**DOE/LX/07-2499&D1
Primary Document**

**Compilation of Meeting Summaries and White Papers
(Fiscal Year 2023)**

**A Product of the Paducah Gaseous Diffusion Plant
Site Groundwater Modeling Working Group**

Date Issued—January 2024

Figure 4. Structural Features in the Paducah Site Area

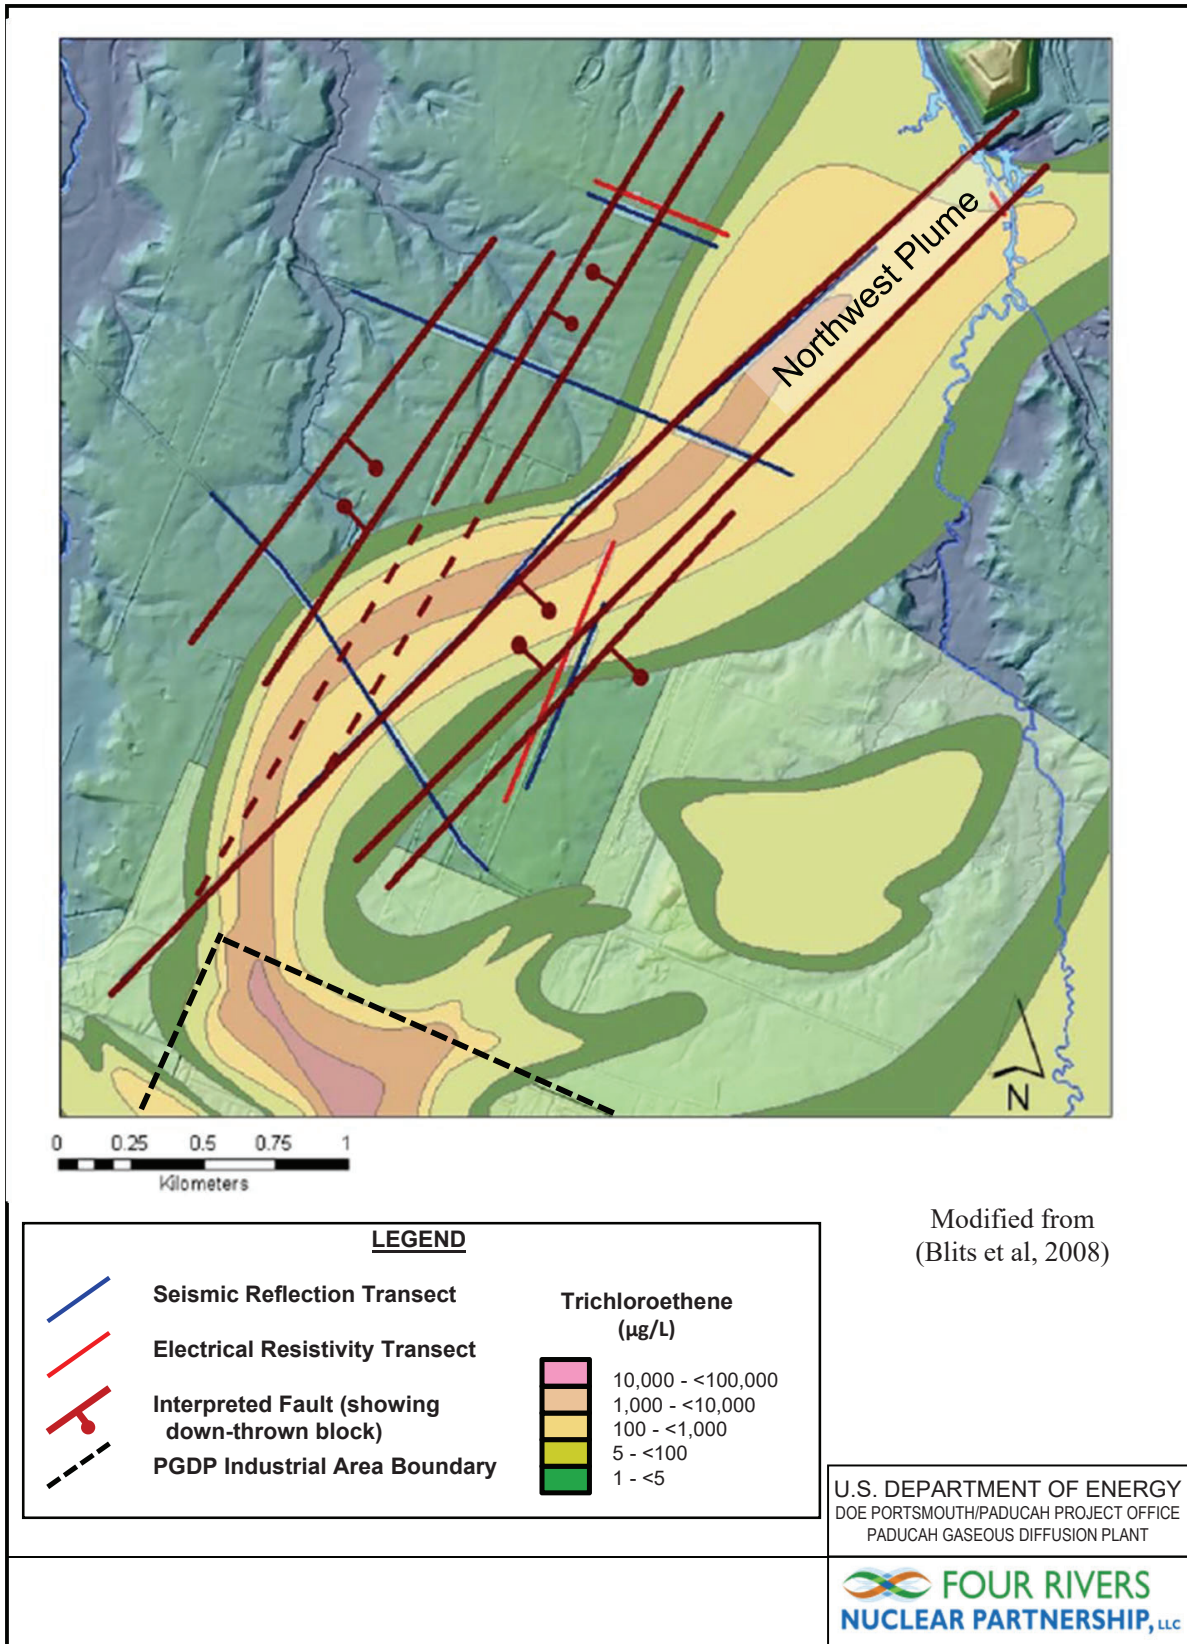
Comment 5: In Figure 4 (Interpreted Structural Features in the PGDP Area, Page 12), the interpreted fault symbol with red dot is defined in the legend as “showing dip”. However, it is noted the dot side of the interpreted fault symbol is intended to show the relative sense of movement and technically indicates the downthrown block or graben and not “dip”.
